Inspection / Service Requirement:

Parachute Swivel

Applies To:

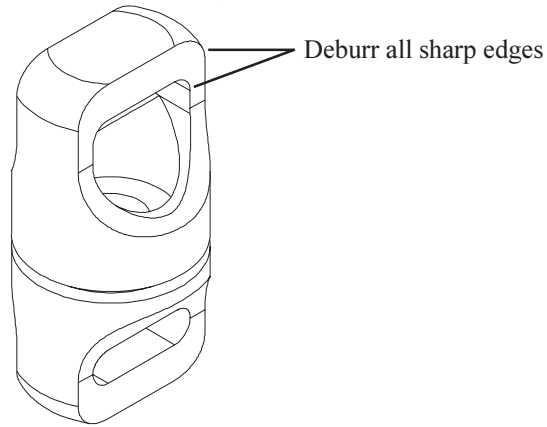
A number of early model parachute swivels were produced with sharp edges which could cut the parachute bridle webbing during a deployment. (The swivel pictured below is the later model, which is not subject to this problem). Early model swivels are aluminum colored, while later models are anodized blue. Not all aluminum colored swivels are subject to this problem, but all swivels which are subject are aluminum colored.

To inspect your swivel, pull the webbing towards the side of the slot and feel the edges along the top of the slot. If they feel sharp, you need to deburr these edges, and also the edges in the corners and on the sides of the webbing slots with a small file. It is not necessary to remove the bridle to do this. You should inspect the bridle during this process for any sign of damage.

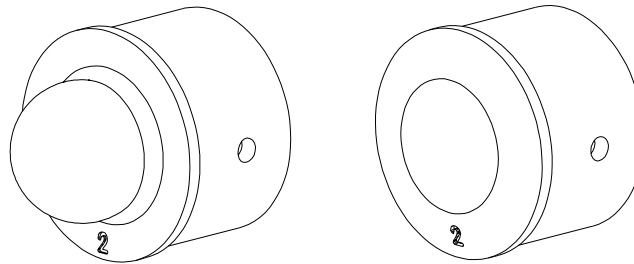
This set can be identified by a “2” stamped into the part (shown below).

These two types of ball socket joints cannot be interchanged.

Fusion Type 1 Hang System

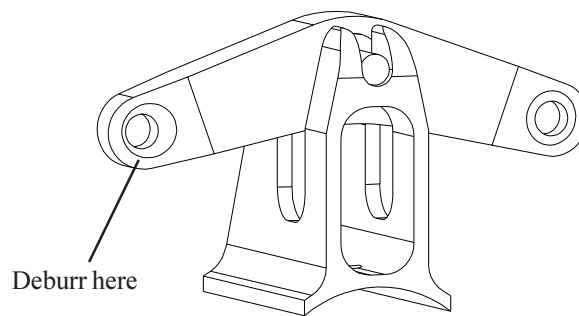
The first Fusions used a four strand 7mm accessory cord main hang loop tied with a grapevine knot (as illustrated in the Fusion Owner's Manual). There are two service related concerns with this loop:

- 1) We have had reports of wear on the sheath of the accessory cord where it passes through the hole in the spreader bar.
- 2) We have had reports of the hot knifed end of the accessory cord cutting through the load bearing strand of the accessory cord.

Fusion main hang loops of this type must be carefully inspected. If any wear is apparent, the accessory cord must be replaced. If wear is apparent where the cord passes through the hole in the spreader bar, this area of the spreader bar must be thoroughly de-burred to remove any sharp edges.

Fusion Type 2 Hang System

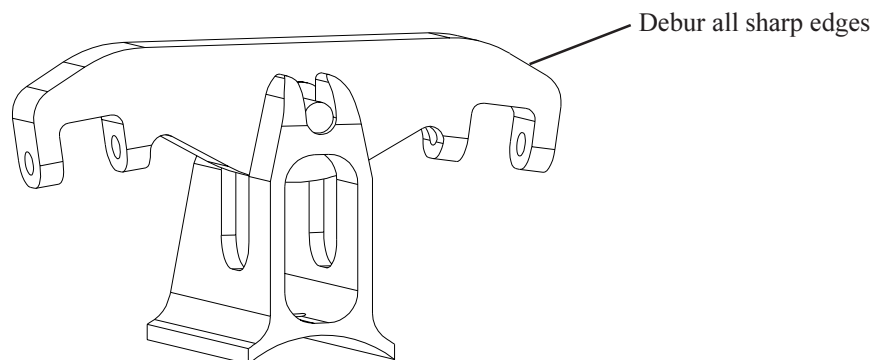
The current Fusions feature a webbing loop mounted to a newly designed spreader bar. The early spreader bars were machined with edges which were not adequately broken in the machining process, and which are unacceptably sharp. As a result, it is possible that during transport of the glider, the loop can be cut or abraded by contact with the spreader bar. Spreader bars of this type on gliders assembled prior to July 7th 1997 must be inspected for sharp edges and carefully de-burred as necessary. Replace any hang loop showing any sign of wear or damage.

**Old style carbon sprog 40M-1161
with 20G-2440 fork**

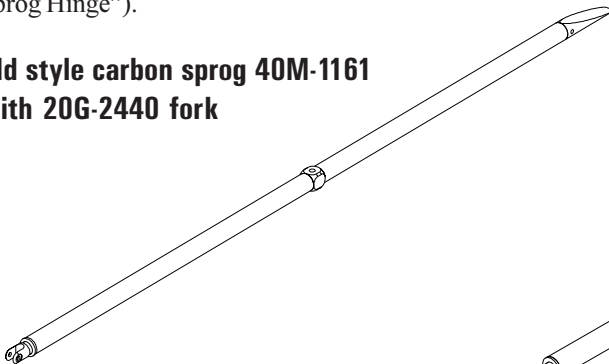
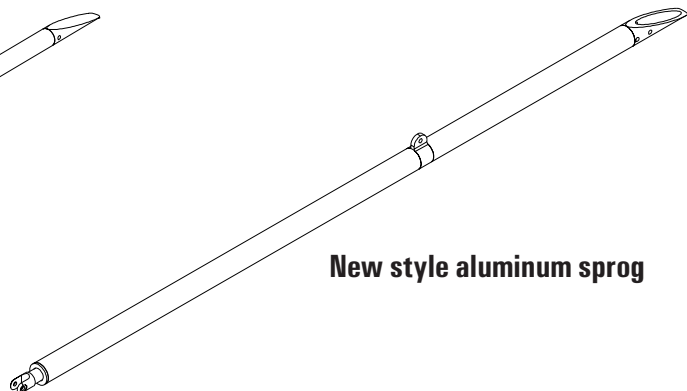
All Fusions manufactured after June of 1998 will be made with a new sprog design, utilizing a new, all 7075 aluminum tube, a new center fitting, a new rear paddle, a new cable, and a new threaded insert and stainless steel threaded fork. These parts, taken together as an assembly, with the addition of a longer bolt to mount the cable to the leading edge bracket, are backwards compatible with all earlier Fusions. In addition, the new threaded sprog fork is backwards compatible with the earlier carbon reinforced sprog tubes (if the original threaded insert is undamaged).

A sprog upgrade kit, including aluminum sprog tube assemblies, cables, and necessary bolts and nuts for 50% of normal price, or \$75 retail per sprog. Installation will require a complete readjustment of the sprog angle (stability settings) and a test flight by a factory authorized technician or dealer, at your expense.

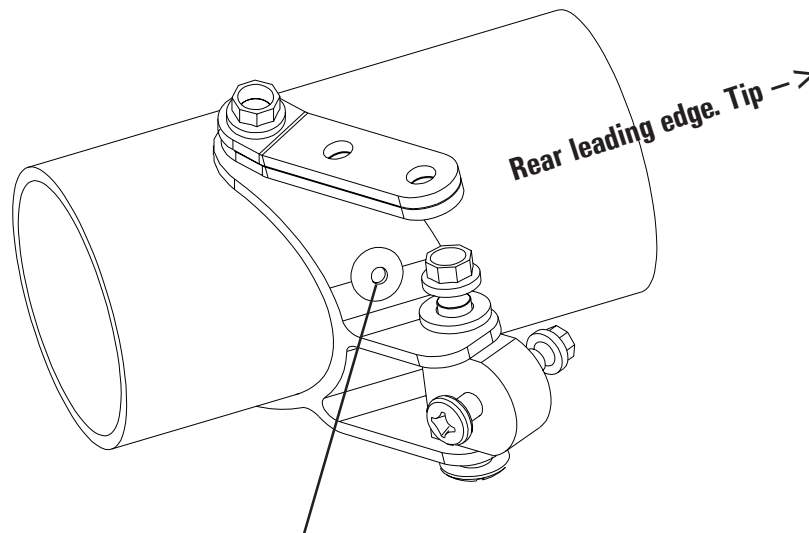
Recently, a Fusion owner performing a routine pre-flight inspection reported that the rivets which secure the orientation of the sprog bracket to the back of the leading edge tube were sheared off. The rivet is essential to the structural integrity of the sprog assembly. The cause of the rivet failure is unknown.

Refer the diagram below. Inspect the rivet fastening the bracket to the backside of the leading edge tube. The 3/16 diameter rivet (part number 10R-0366 Rivet AL 3/16 x .350 Cherry AAPQ6-4) is a high strength 'retained mandrel' type. If the mandrel is missing or the mandrel end is recessed more than 1/16 inches (.063) below the rivet head, the assembly should be considered unairworthy until the rivet is replaced. Replacement rivets are available without charge from Wills Wing. Please include 'Reference TB980709' and your glider number with your request.

Inspect rivet center for retained mandrel. Replace rivet if mandrel is missing or recessed more than 1/16 inch below surface of rivet dome

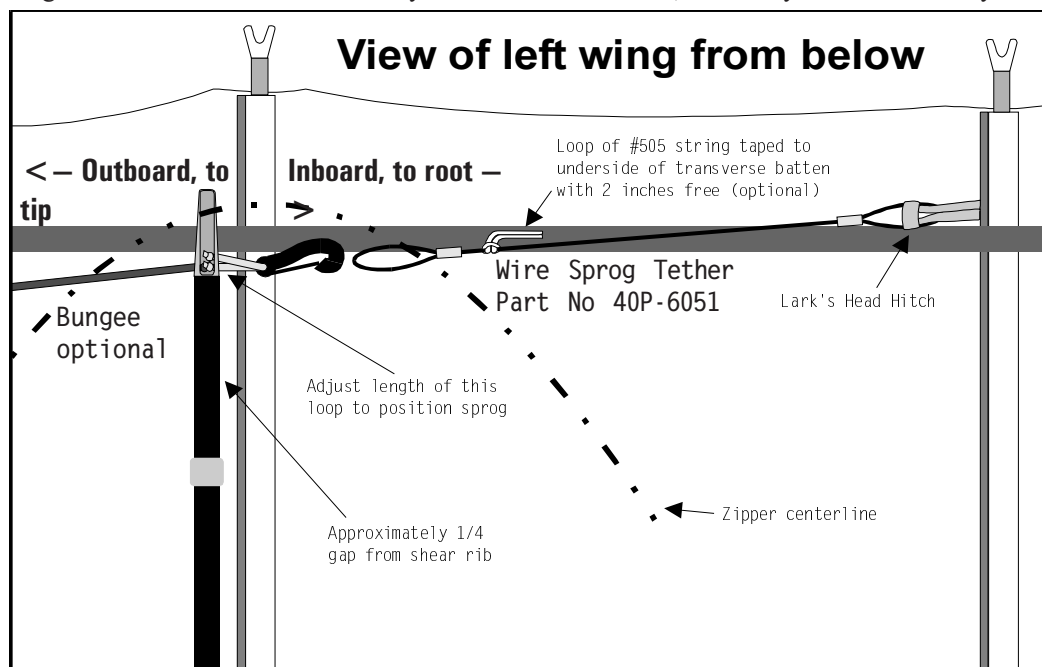
Effective July 1998 we have changed the tether assembly which secures the sprog in proper orientation to the transverse batten. The new assembly is both easier to connect and to adjust. There is no requirement to upgrade the earlier configuration to this new configuration.

1. Remove 505 tether and old snap clip from the sail and discard the clip.
2. Install the new tether cable onto the sail by larks heading one end to the loop sewn to the sail as shown.

3. Cut a one foot piece of the 505 leech line to use to attach the new snap clip to the sprog paddle.
4. Attach the clip to the paddle as shown using a single overhand knot inside the paddle cut-out on each end of the leech line. Adjust the length of the leech line loop so as to position the sprog $\frac{1}{4}$ to $\frac{1}{2}$ inch from the fabric rib.

5. If your glider has the new style transverse batten installation where the batten is not enclosed in a full length pocket, larks head an eight inch length of leech line, doubled over, to the sprog tether cable as shown and tape it to the bottom of the transverse batten as shown. This will prevent the cable from wrapping around the batten.

Diagram 2
If necessary, file bushing heads to 1/16 (.063) above tube

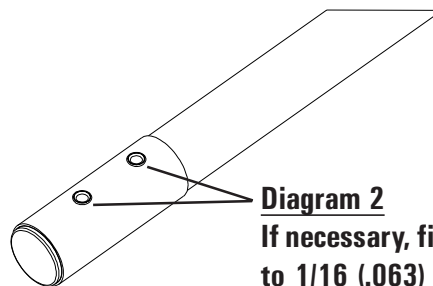
The resistance to turning provided by the locking feature of the nut during installation equates to about 2 lbs of force at the end of a four inch long wrench. Elastic compression of the parts which the bolt and nut are securing may as much as double this force as the nut reaches full tightness. If you need to exert more torque than this, you are over-tightening the nut. If you cannot achieve the minimum one full thread and .036” of engagement as indicated without over-tightening the nut, you must do one of the following:

1. Remove washers, or substitute thin washers for thick washers.
2. Use a flat file to reduce the height of the heads of aluminum bushings to 1/16” (.063”) above the tube.
3. Replace the bolt with a longer bolt.

Keyhole Collar

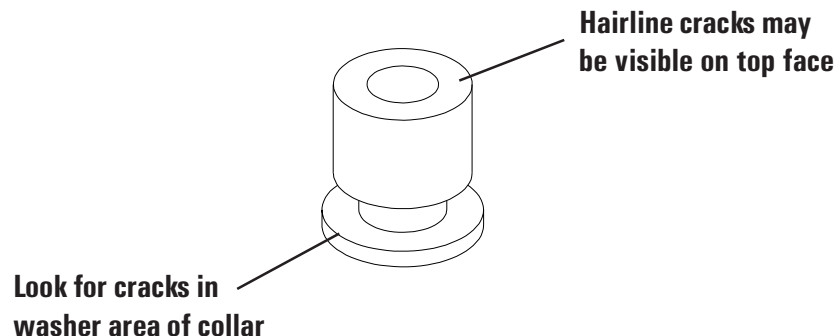
Recently we have seen three incidents of partial failures of this collar. The nature of these failures has ranged from cracks appearing in the part, to a separation of part or all of the “washer” area of the collar from the remainder of the part. In one case, the failure of the collar was coincident with, though apparently not the cause of, the nose wires becoming detached from the noseplate. (The apparent cause of both the wires becoming detached and the failure of the collar in this incident was the fact that the nut which holds the collar on came off of the bolt. See TB# 980716 for more information on this.) As near as we can determine, even a complete, catastrophic failure of the collar would not allow the wires to become detached in flight, so long as the nut remains in place, as either the nut or the head of the bolt (depending on the configuration) would retain the keyhole tang.

However, in our investigation of these incidents we have determined that the part as manufactured is unacceptably brittle, and can be expected to be subject to some probability of failure in normal use. We are therefore recalling all of these parts, and requiring their replacement. We have manufactured new parts out of a different, stronger and less brittle material. The new parts can be distinguished by the color of the plating. The original parts are gold colored 'Cad II' (the same as most AN bolts). The new style replacement parts are silver colored 'Cad I'.

Replace both keyhole collars on your glider with new ones. You may obtain new ones through your dealer, or direct from Wills Wing. Please supply the model and serial # of your glider. Note that Falcon 225's use a slightly different collar on the rear keel; it has a wider necked area to accept two keyhole tangs. We will supply parts at no charge on a warranty basis for any gliders manufactured within the last year. We will make the collars available for \$1.50 each (normal retail price is \$3.00 - \$4.50) for gliders more than one year old.
